Product Change Notification / ASER-13KWIQ013

CCB 4978 Initial Notice: Qualification of MMT as an additional assembly site for selected ATSAME5xxx and ATSAMD5xxx device families available in 128L TQFP (14x14x1mm) package.

QUALIFICATION PLAN SUMMARY

CCB 4978
Pre and Post Change Summary
PCN #: ASER-13KWIQ013

Lead Frame Design Comparison

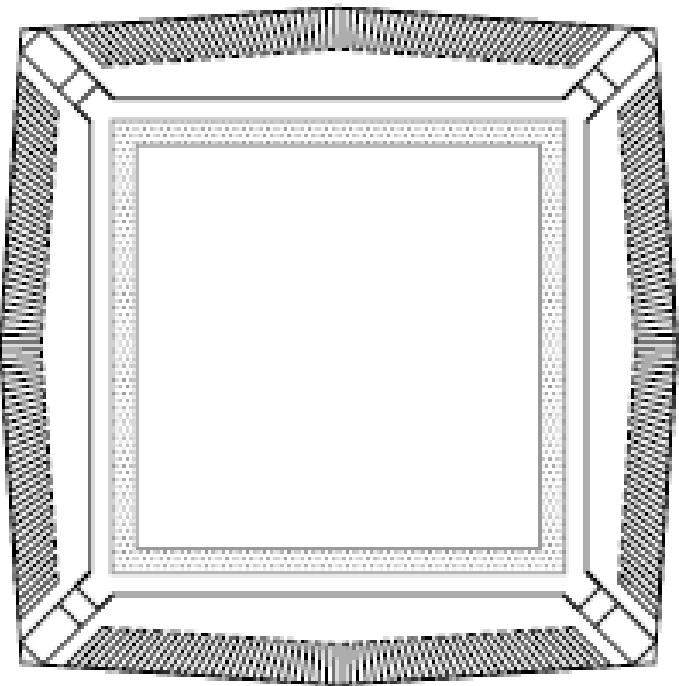
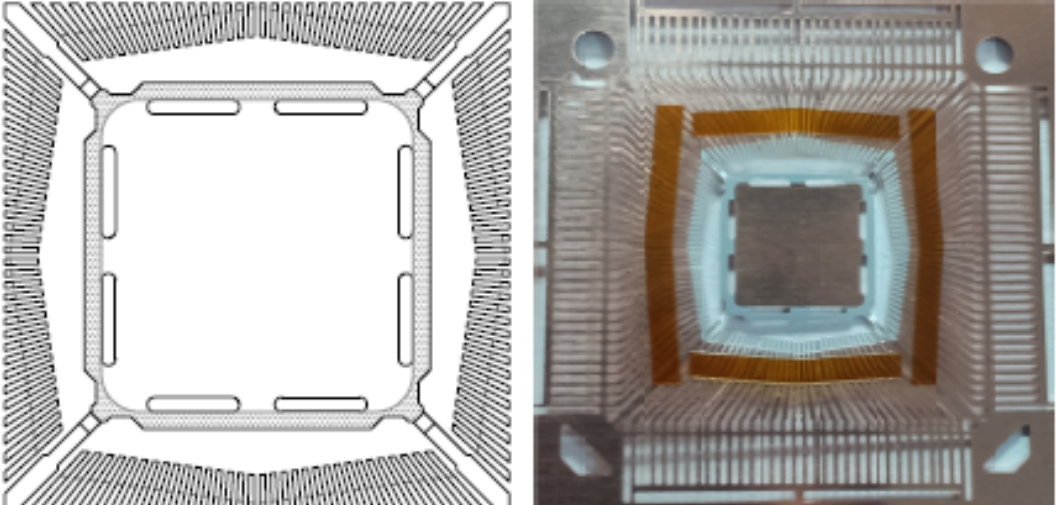
ASE	MMT				
 <p>A detailed technical drawing of an ASE lead frame. It features a square central cavity surrounded by a thick, multi-layered frame. The frame has a complex, textured appearance with various internal patterns and a slightly irregular, hand-drawn style.</p> <table border="1" data-bbox="484 1153 1026 1239"><tr><td>Paddle Size</td><td>240x240 mils</td></tr></table>	Paddle Size	240x240 mils	 <p>Two images of an MMT lead frame. On the left is a technical drawing showing a square central cavity with a more uniform, grid-like frame structure. On the right is a photograph of the physical lead frame, showing its metallic, perforated appearance and the central cavity.</p> <table border="1" data-bbox="1574 1153 2117 1239"><tr><td>Paddle Size</td><td>190x190 mils</td></tr></table>	Paddle Size	190x190 mils
Paddle Size	240x240 mils				
Paddle Size	190x190 mils
